PLANNING REPORT

Planning and Zoning Commission

Aura Dublin 26-045PDP

26-045PDP - Aura Dublin (Sawmill Outparcel)

Proposed Pocket Plaza in blue hatch

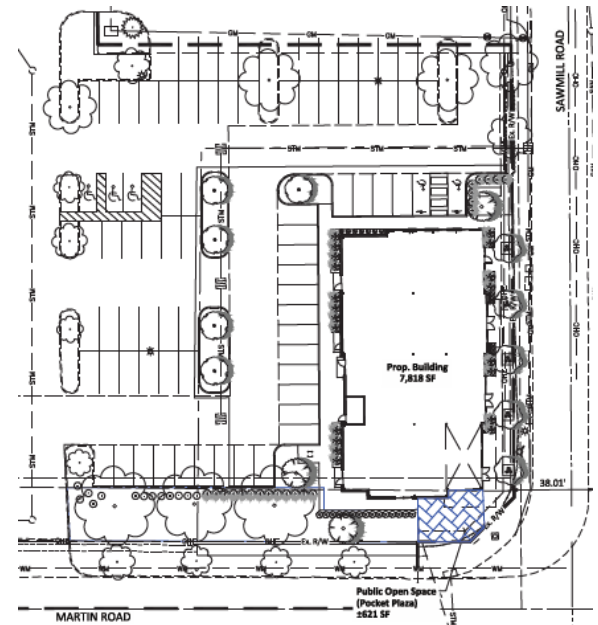
The open space as shown is located at the corner of Sawmill and Martin Roads and is intended to partially satisfy the RBZ requirement. Staff finds this location is unsuitable for public open space given the high amount of vehicular traffic that frequents this corner at high speeds, though a private patio may be appropriate here. Pocket Plazas are intended to serve as a small impromptu gathering space for civic, social, and commercial purposes, and they should be designed as a well-defined area of refuge separate from the public sidewalk. The open space as proposed does not meet the intent and requirements of a Pocket Plaza.

Given the unique site layout, the limited options for public open space that meet the full intent of the Code, the minimal square footage of open space required for this development, and the RBZ treatment requirement being satisfied by the use of landscaping, staff encourages the applicant to consider the fee-in-lieu of open space option.

The size of open space provided is incorrectly labeled on the drawings. This should either be corrected in the FDP submittal, or if the applicant proceeds with the fee-in-lieu option, this should be removed. This has been addressed with a recommended condition of approval.

3. The applicant shall update the Site Plan to reflect the accurate Required Building Zone at the FDP stage.
4. The applicant shall continue to work with staff on best addressing the intent of the open space standards and update the applicable open space square footage to accurately reflect the proposal at FDP.
